ADDENDUM

NO. 1

PROJECT NAME: Tomball ISD Intermediate School Replacement

ADDENDUM DATE: Tuesday, July 28, 2026

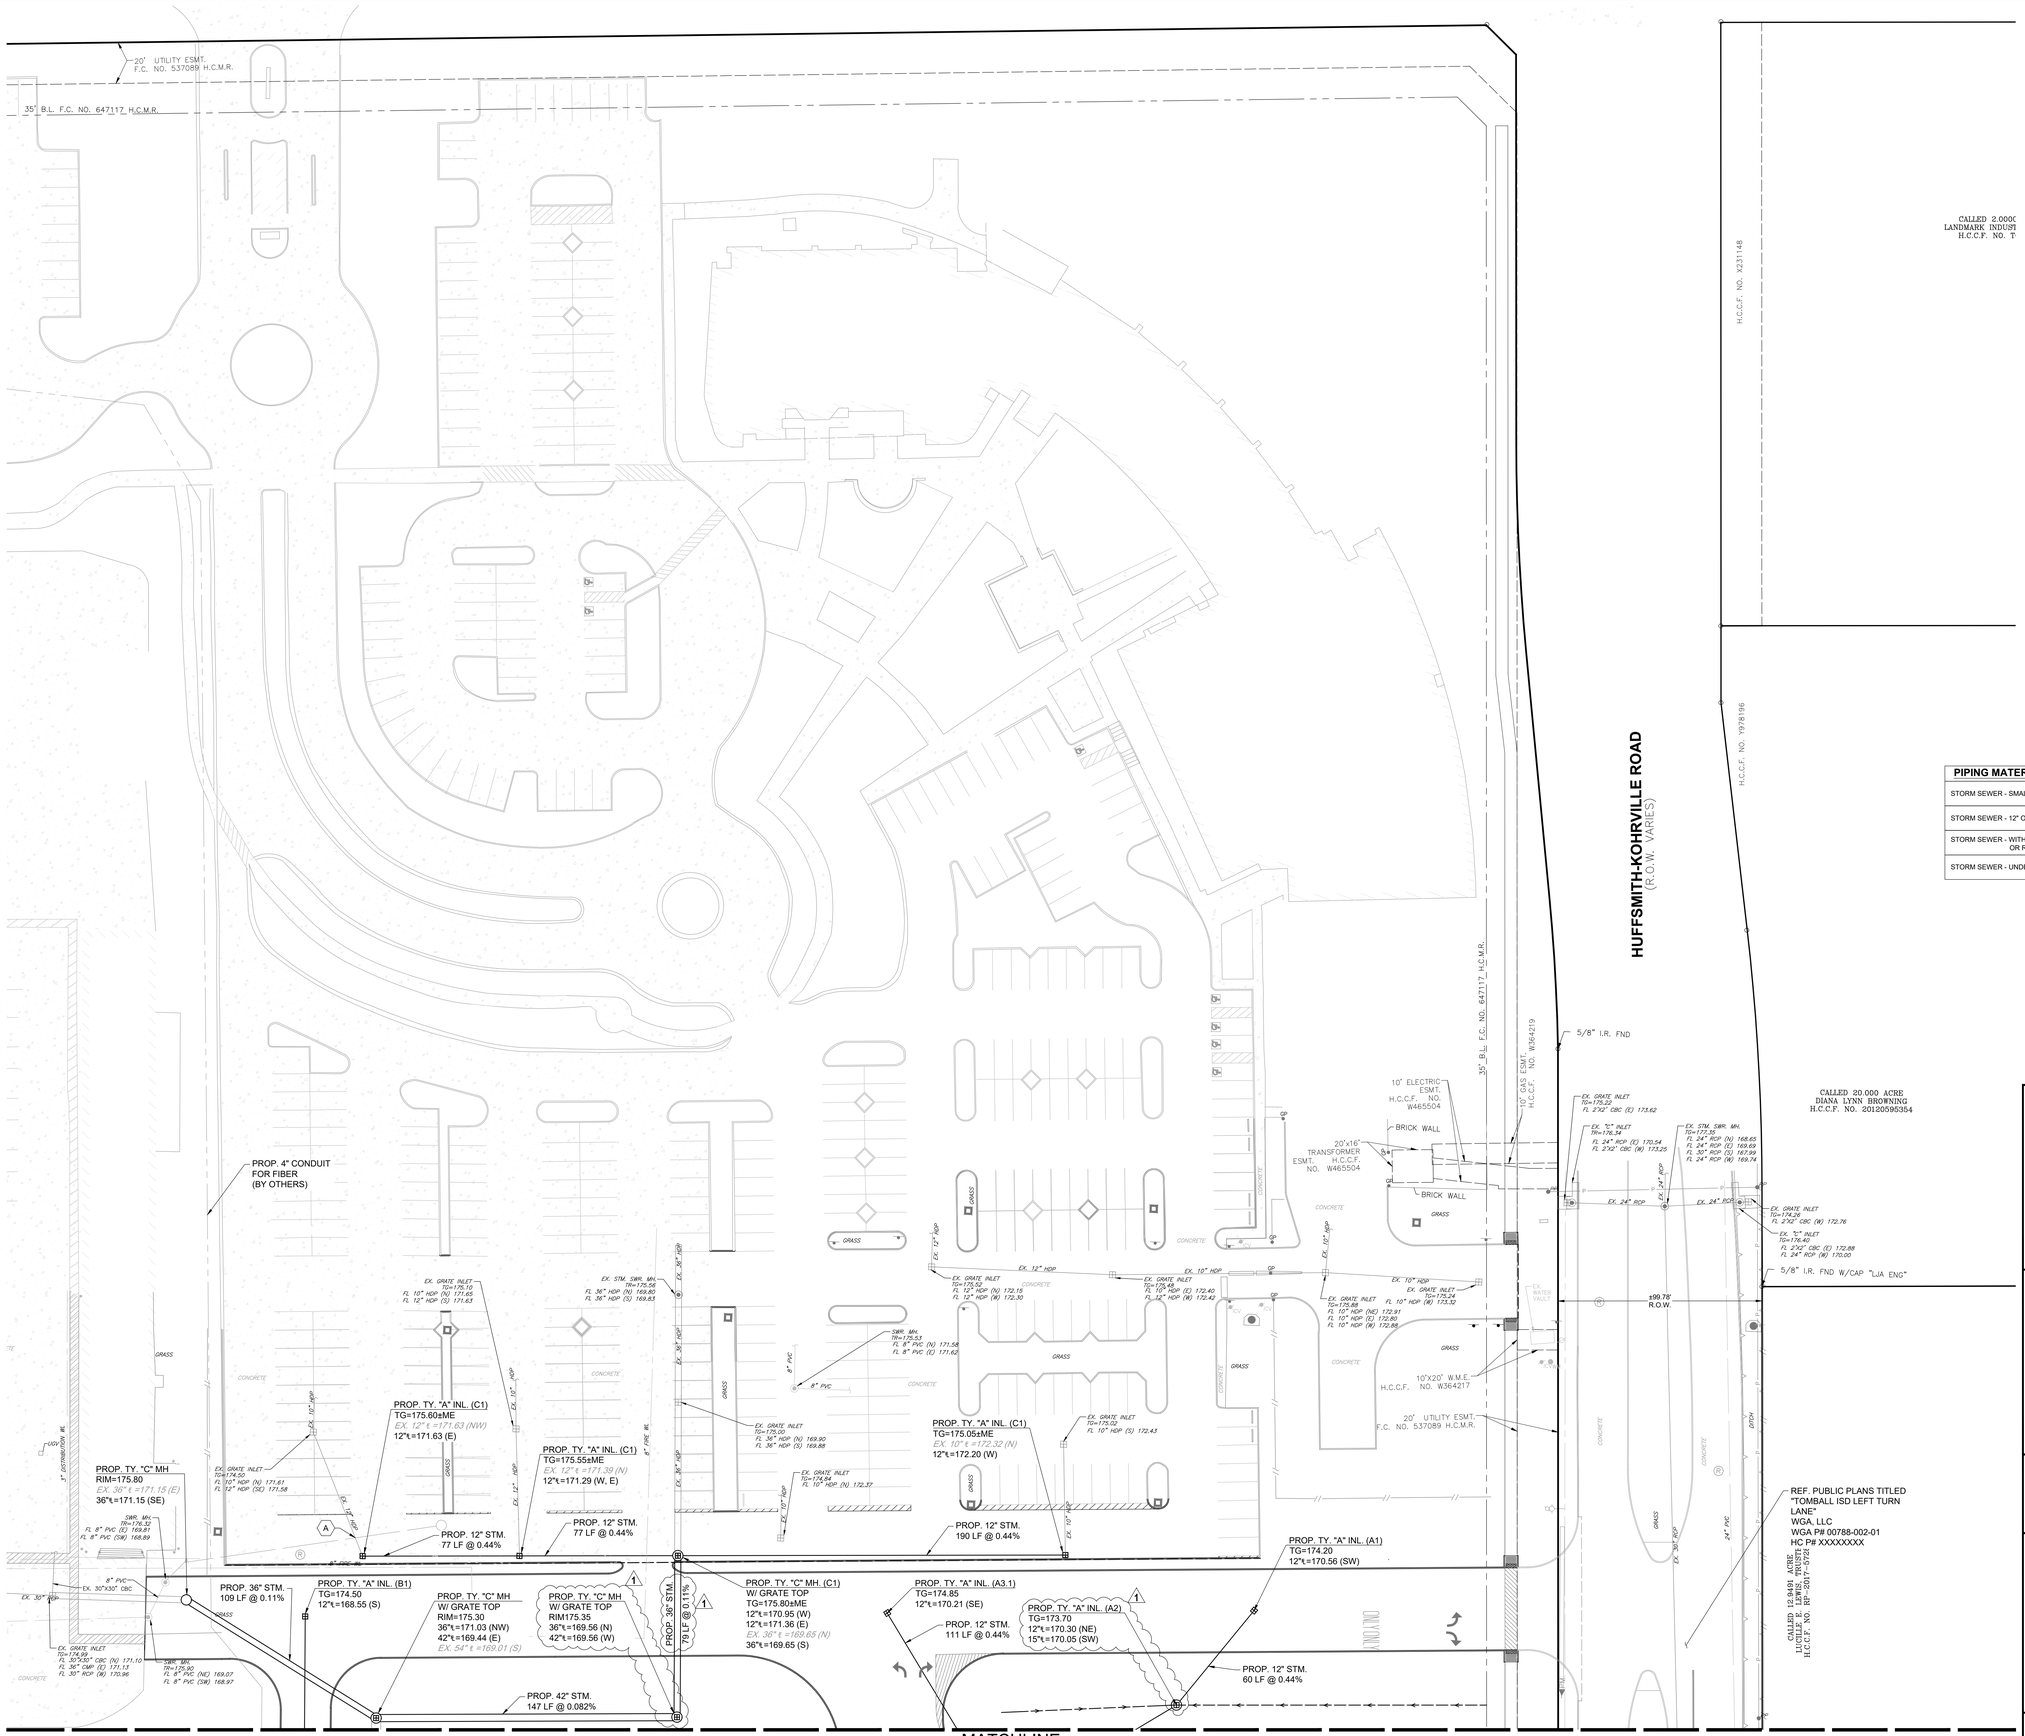
- Tetherballs proposed by others have been relocated.
- Inlet orientations have been revised to be parallel to the storm sewer, where applicable. Please refer to Sheets C6.1 and C6.2.

AD No 1, Civil. Item 9: **To the Drawings, C6.1, "UTILITY PLAN – STORM SEWER (1 OF 2)"**
Description.

2 L1.2 **ENLARGEMENT OF PLAYGROUND LANDSCAPE PLAN**
SCALE: 1" = 10'-0"
SCALE: 1"=10'

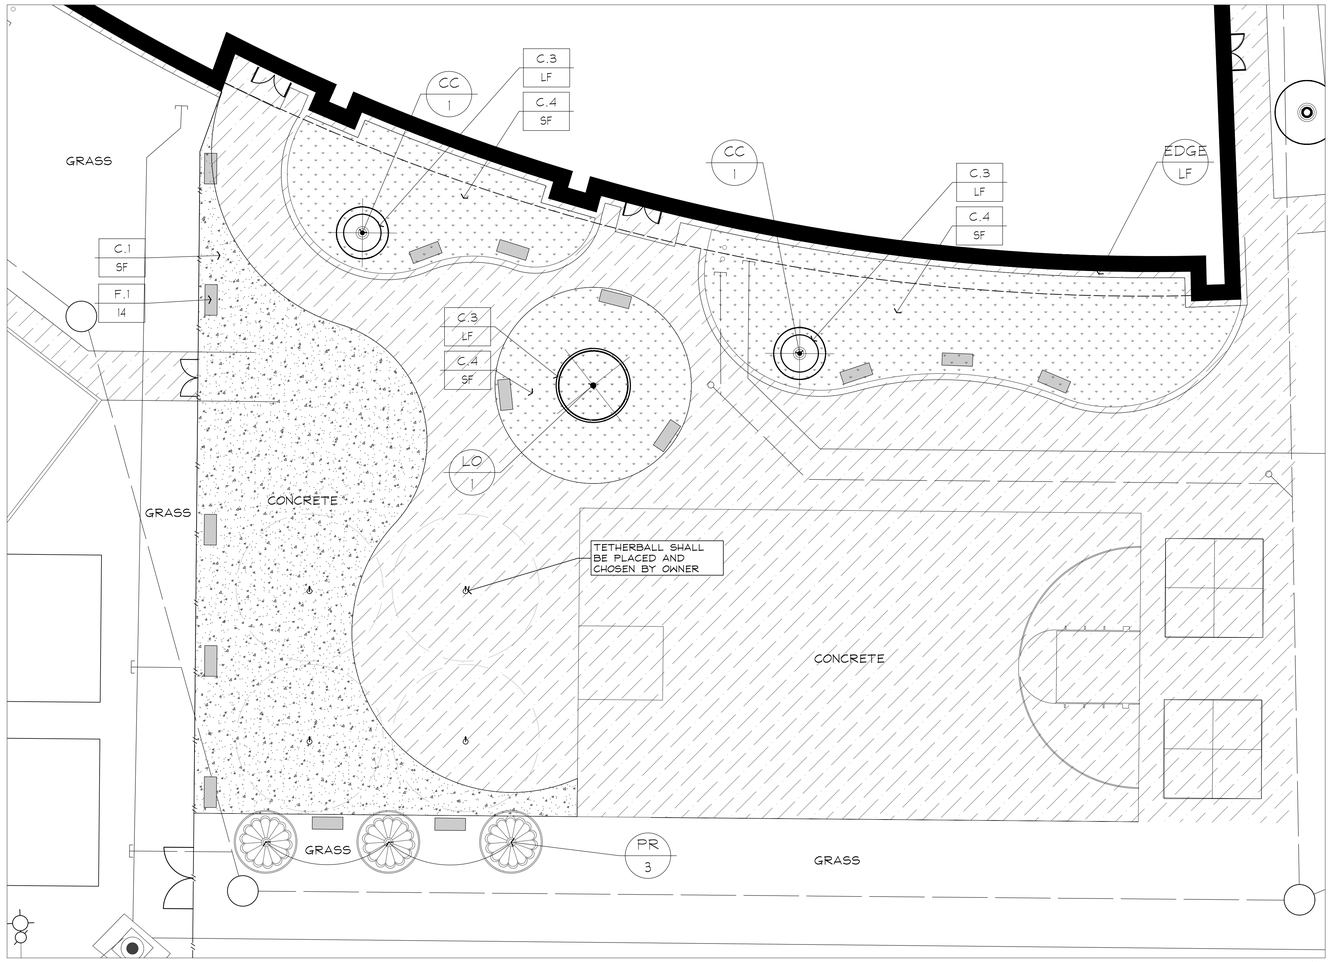
AD No 1, Land Item 1: **To the Drawings, Sheet L1.2, "ENLARGEMENT LANDSDCAPE PLAN"**
Paving and landscape adjusted to coordinate with new fence line. Tree and bench locations have been adjusted to this as well. Landscape and Hardscape legends have been updated with more information on types and finishes.
Details for concrete bench locations and conditions have been added as well as details on artificial turf installation.

1 ARCHITECTURAL SITE PLAN - OVERALL
1" = 30'-0"

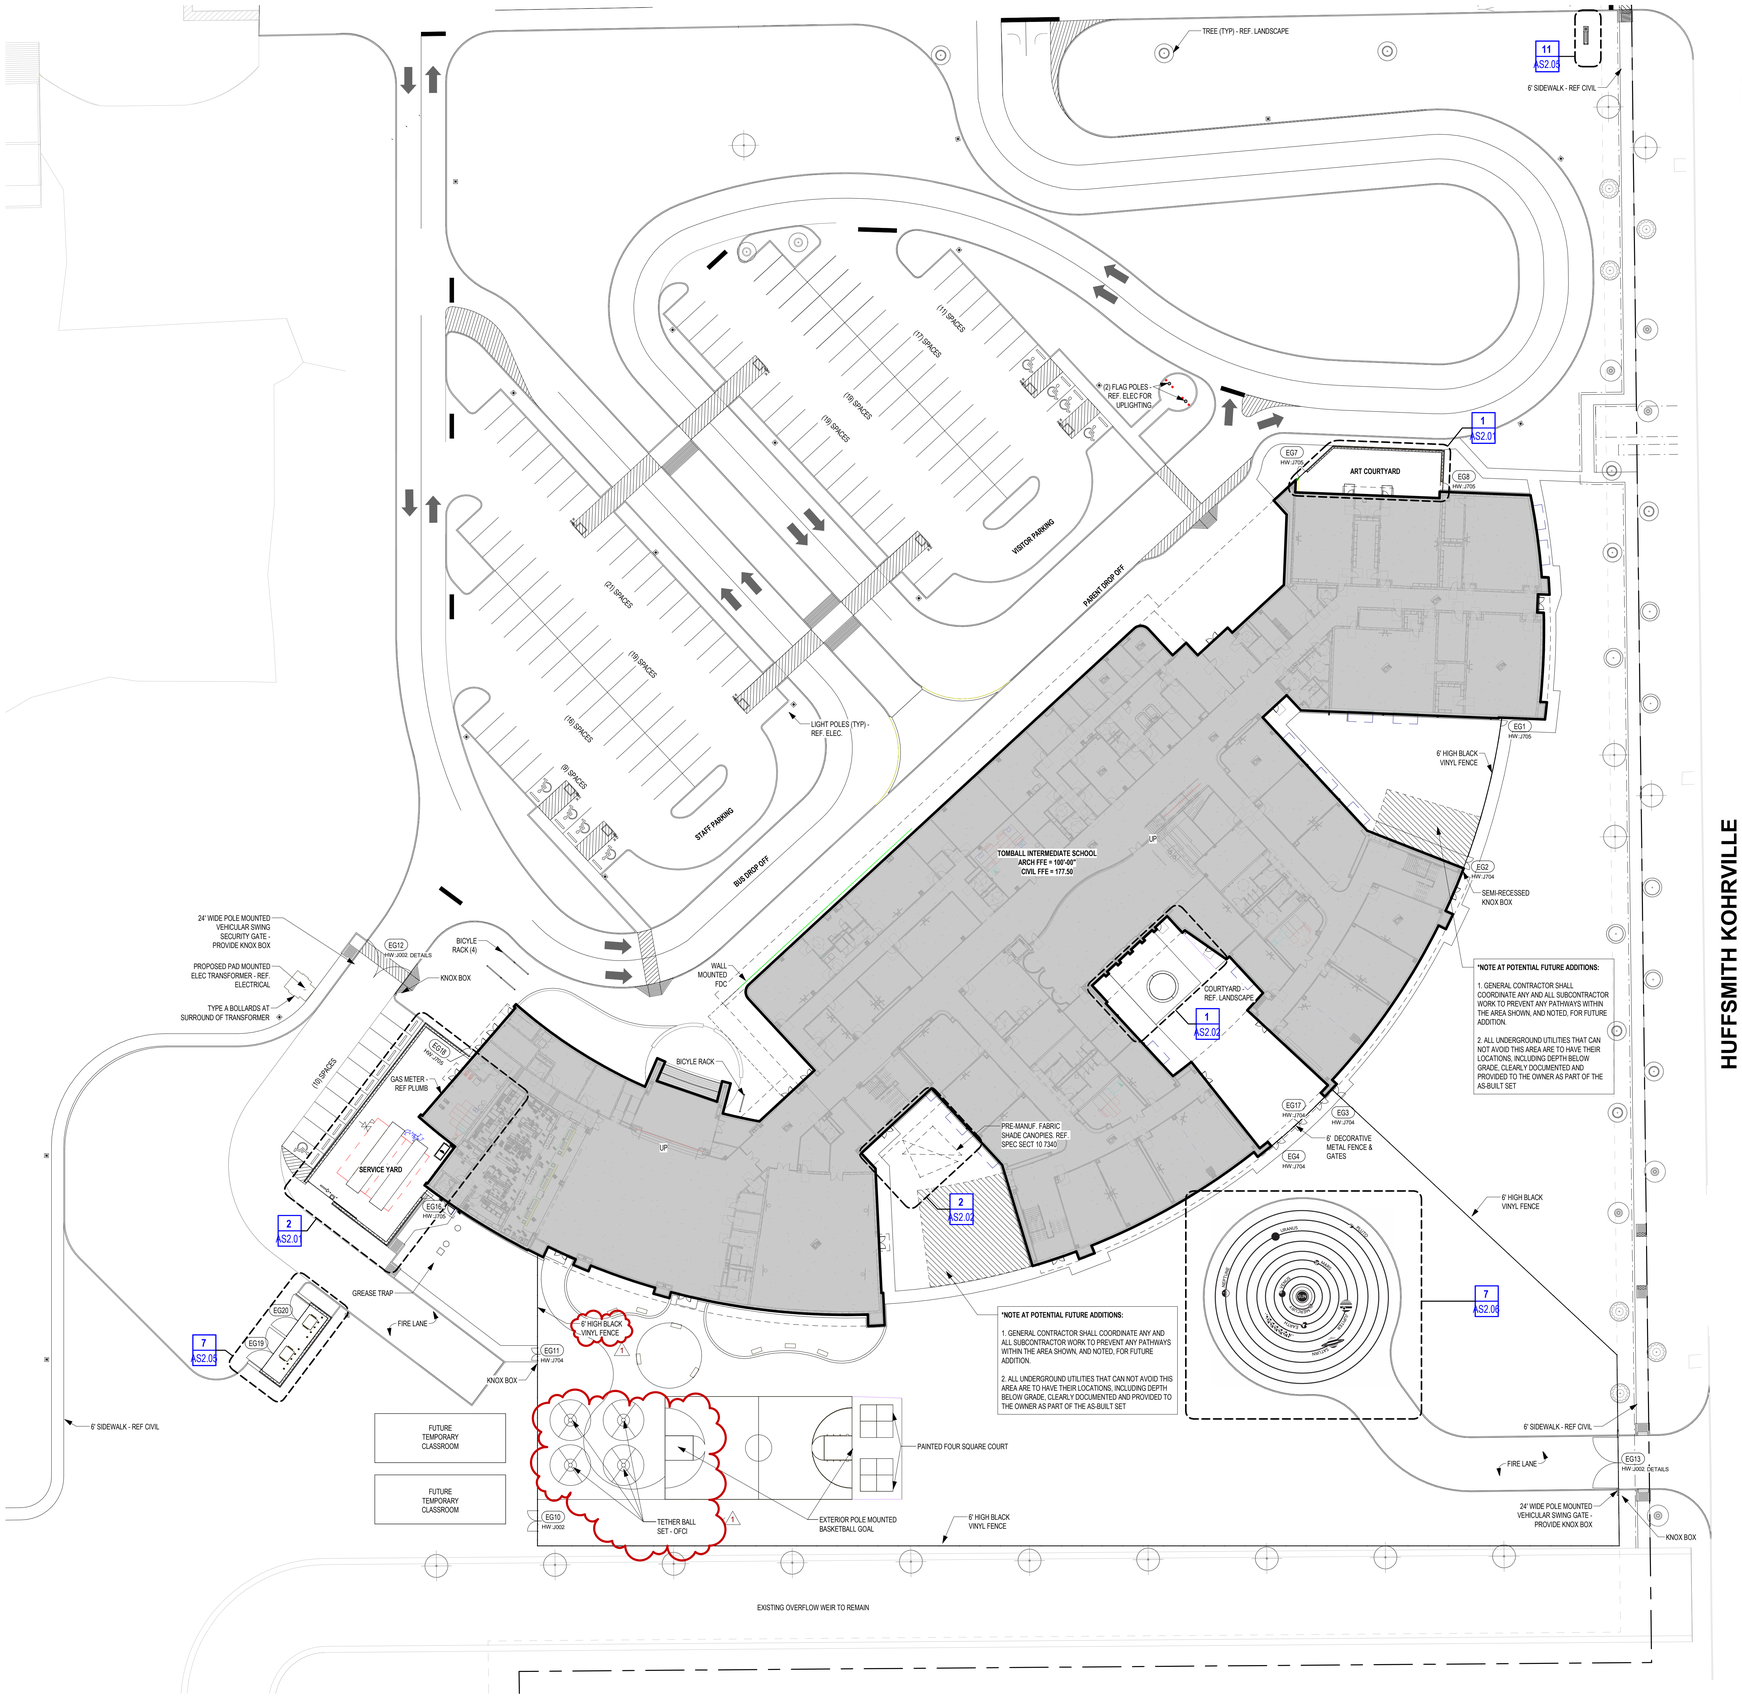
AD No 1, Arch. Item 3: **To the Drawings, Sheet AS1.02,"ENLARGED SITE PLAN"**
Updated west fence to be 6' H to match other site fence.
Updated perimeter of site finishes to align with west fence.

1 ROOF FRAMING PLAN - AREA B
S6.07 1/8" = 1'-0"

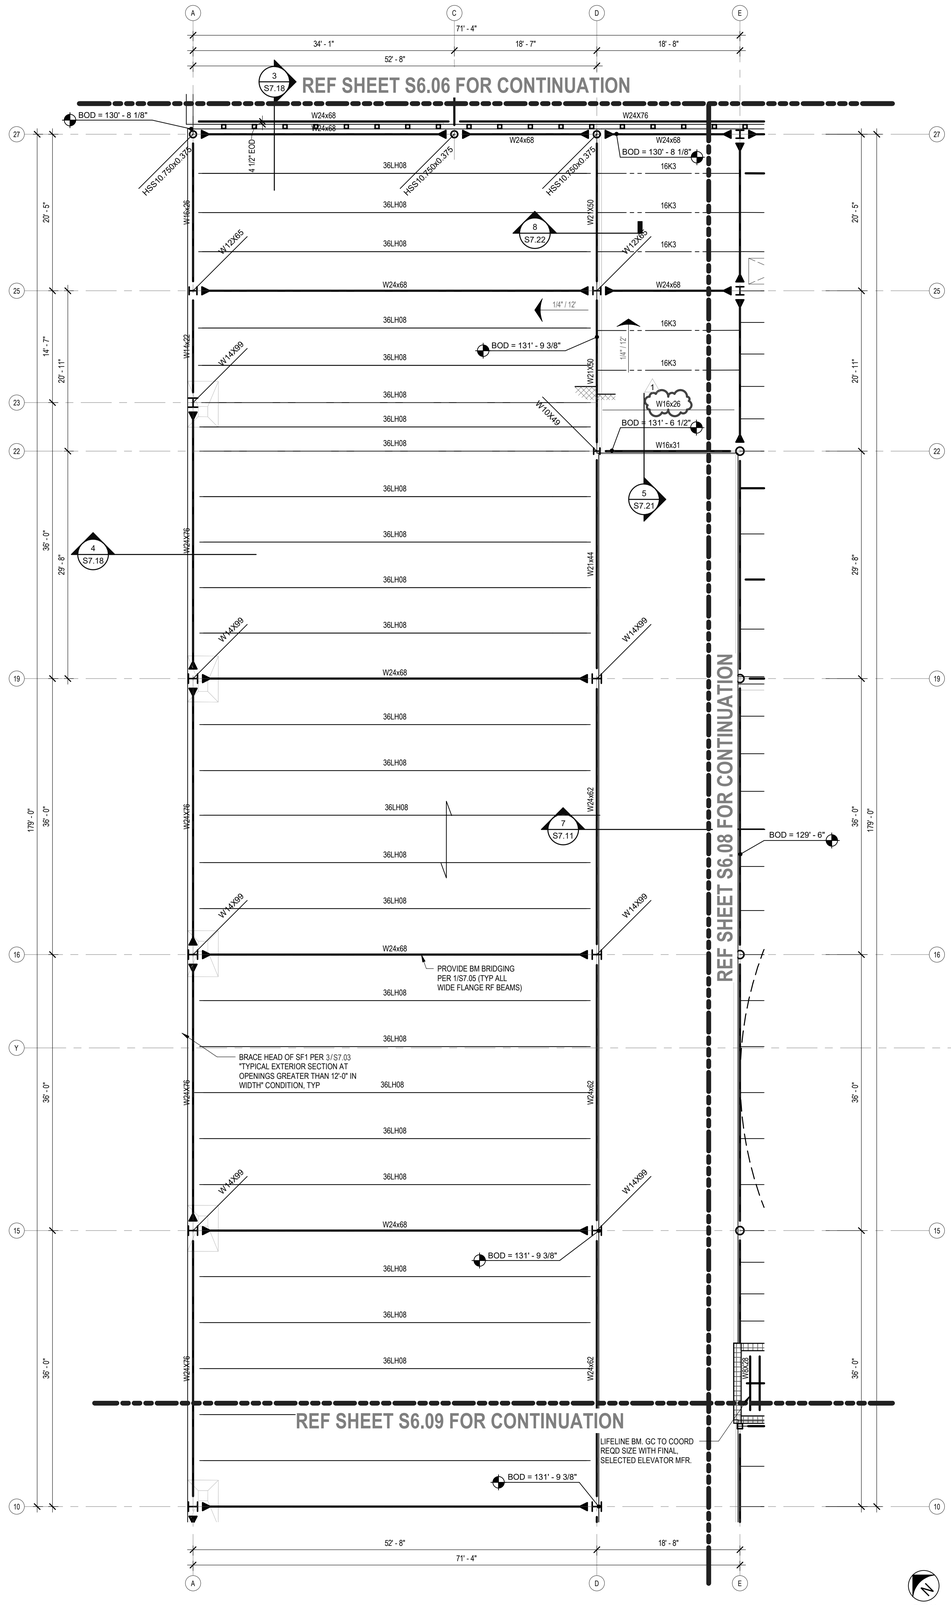
AD No 1, Struc. Item 5: To the Drawings, Sheet S6.07,"ROOF FRAMING PLAN - AREA B"
Changed roof purlin size.
